1. Type of Well ⊠ Oil Well	8. Well Name and PEACHES 19	d No. 9 FEDERAL	3H					
2. Name of Opera			DAVID STEWAR	T ·	<u></u>	9. API Well No. 30-015-424	46-00-X1	
	/AY PLAZA STE 1 , TX 77046-0521	10	3b. Phone No. (inc Ph: 432.685.57	lude area code 17 <b>HOBB</b>	SOCD	10. Field and Poo COTTONW	ol, or Explora OOD DRA	tory W
		., R., M., or Survey Description	) )	fanc 1	1 2015	11. County or Pa	arish, and Stat	e
	S R27E SESW 07 N Lat, 104.230748					EDDY COU	JNTY, NM	
J	12. CHECK APPE	ROPRIATE BOX(ES) TO	O INDICATE NA		EVED NOTICE, R	EPORT, OR OI	THER DAT	ГА
TYPE OF S	SUBMISSION			TYPE O	F ACTION	<u></u>		·
Notice of	Intent	□ Acidize	🗋 Deepen		D Produc	tion (Start/Resum	· .—	Vater Shut-Off
🗖 Subsequer	nt Report	<ul> <li>Alter Casing</li> <li>Casing Repair</li> </ul>	Fracture New Co		□ Reclam □ Recom		ØC	Vell Integrity Other
🗖 Final Aba	ndonment Notice	□ Change Plans □ Convert to Injection	<ul><li>Plug and</li><li>Plug Bas</li></ul>		□ Tempo □ Water	rarily Abandon Disposal	Cha PD	nge to Original

#### Additional data for EC transaction #308050 that would not fit on the form

## Permian Drilling Hydrogen Sulfide Drilling Operations Plan Peaches 19 Federal 3H

## PECOS DISTRICT CONDITIONS OF

# 5M Choke Panel

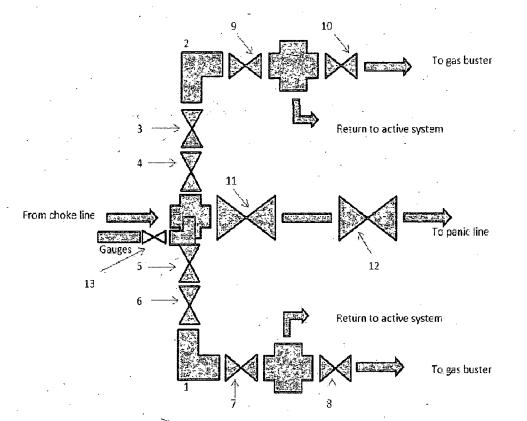
4. The Operator will connect the BOP choke outlet to the choke manifold using a hose that meets all BLM requirements and will be inspected and approved by BLM personnel prior to spud.

- 2. Variance approved to use flex line from BOP to choke manifold. Check condition of flexible line from BOP to choke manifold, replace if exterior is damaged or if line fails test. Line to be as straight as possible with no hard bends and is to be anchored according to Manufacturer's requirements. The flexible hose can be exchanged with a hose of equal size and equal or greater pressure rating. Anchor requirements, specification sheet and hydrostatic pressure test certification matching the hose in service, to be onsite for review. These documents shall be posted in the company man's trailer and on the rig floor. If the BLM inspector questions the straightness of the hose, a BLM engineer will be contacted and will review in the field or via picture supplied by inspector to determine if changes are required (operator shall expect delays if this occurs).

# 10M Remote KII Line Schematic

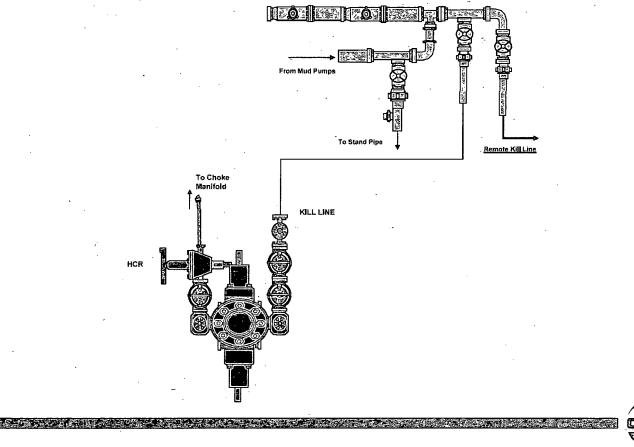
5M system requires an HCR valve, remote kill line and annular to match. The remote kill line is to be installed prior to testing the system and tested to stack pressure.
